FORM APPROVED  
OMB NO. 1004-0137  
Expires: January 31, 2018SUNDRY NOTICES AND REPORTS ON WELLS  
Do not use this form for proposals to drill or plug an  
abandoned well. Use form 3160-3 (APD) for such proposals.5. Lease Serial No.  
NMNM23765  
6. If Indian, Allottee or Tribe Name

8. Well Name and No.  
PHILLIPS SWD FEDERAL 19. API Well No.  
30-015-25530-00-S110. Field and Pool or Exploratory Area  
UNKNOWN11. County or Parish, State  
EDDY COUNTY, NM

\*\* BLM REVISED \*\* BLM REVISED \*\* BLM REVISED \*\* BLM REVISED \*\* BLM REVISED \*\*

## Proposed Wellbore Diagram

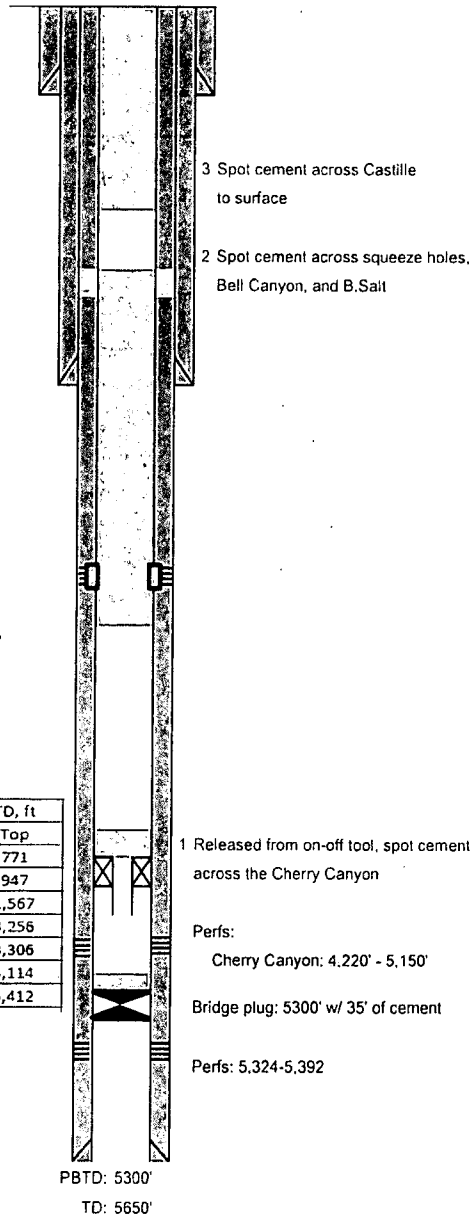
6. Release from on-off tool, if stuck, cut tubing above. Spot Jet-Seal (25 ppb), wait 30 minutes. Spot 60 sx CL "C" Cement f/ 4,153' t/ 3,456', WOC & tag (Perfs, Cherry Canyon). TOC must be at 4,014' or shallower. Ensure to spot enough MLF between cement plugs out in accordance w/ BLM regulations. Wait to spot MLF if casing pressure test failed due to potentially wasting fluid.

7. Spot 40 sx CL "C" Cement f/ 3,356' t/ 2,954' (Bell Canyon, B.Salt, squeeze holes). TOC must be at 2,974' or higher.
  8. Spot 165 sx CL "C" Cement f/ 1,617' t/ surface (Castille, Shoe, FW). Deepest freshwater in the area is ~175'.

9. Cut off wellhead 3' below grade. Verify Cement To Surface, install required dry hole marker as per COA's, turn over to reclamation.
- All cement plugs will be class "C" (<7,500') or "H" (>7,500') with a closed loop system used.
